**UNITED STATES
NUCLEAR REGULATORY COMMISSION**
REGION I
2100 RENAISSANCE BLVD., SUITE 100
KING OF PRUSSIA, PA 19406-2713

EA-15-081

**SUBJECT: PILGRIM NUCLEAR POWER STATION – NRC SPECIAL INSPECTION REPORT
05000293/2015007; AND PRELIMINARY WHITE FINDING**

Diagram of Target Rock SRV from
NRC Information Notice 2003-01, "Failure
of Boiling Water Reactor Target Rock Main
Steam Safety/Relief Valve," dated
January 15, 2003

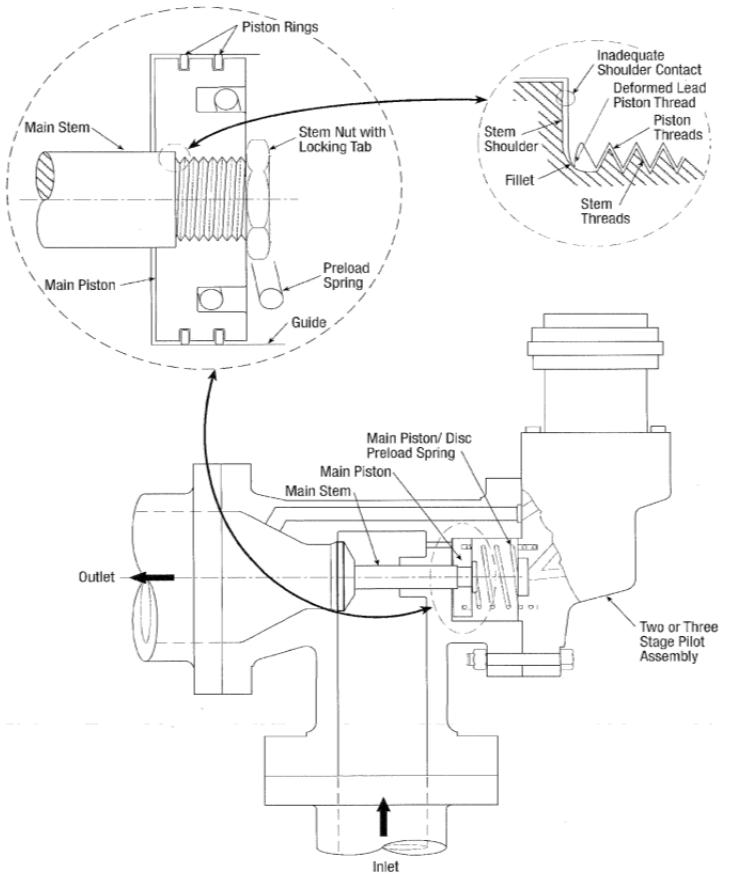
The 'C' SRV was subsequently sent to an offsite testing facility for as-found setpoint verification, low pressure testing, and an inspection of valve internal components. While the 'C' SRV satisfactorily stroked during both the setpoint test and additional low pressure (100 psig) actuation test at the testing facility, the inspection revealed notable damage to some internal valve main stage parts. Specifically, the main valve piston had indications of some scoring and the lower piston ring (two rings in total) was seized within the piston ring. The most noteworthy damage was wear (grooves) in the main operating cylinder liner where the operating piston rings rest while the valve is in its closed position. The cylinder liner wear resulted in resistance to valve operation in the open direction through contact with the operating piston rings. Upon the disassembly, the technicians noted that the piston was not tightly secured and the locking tab was slightly rotated out of its grooved position. In its normal/assembled condition, the main valve stem is threaded into the main piston, torqued, and is secured with a washer and stem nut with locking tab on the opposite side of the piston (See SRV figure below).

The assembly of the valve is such that the main stem is torqued to the piston (100 ft-lbs) and the stem nut is torqued to the threaded end of the main stem (50 ft-lbs). However, there has been prior operating experience, including an instance at PNPS in 2013, where the stem nut was found loose. Based on prior operating experience, there have been separate issues that may have contributed to torque relaxation or looseness at the stem/piston or stem nut interface. These included 1) inadequate stem shoulder contact at the main stem/piston interface, 2) inefficient test gag device that potentially allowed substantial internal valve impact during full pressure setpoint testing, and 3) a stem nut torque value that was less than optimal. It was not apparent that a single item alone was the cause for the identified issues. Further, based on historical operating and internal inspection data, internal wear problems were not assured even when the old style test gag device and lower stem nut torque existed (i.e., human performance/installation and specific in-service vibration levels may also have had negative impacts). The testing facility currently uses a re-designed test gag device to prevent a large impact force during the full pressure bench testing, and the vendor recommended an increased stem nut torque value (100 ft-lbs) in December 2013.
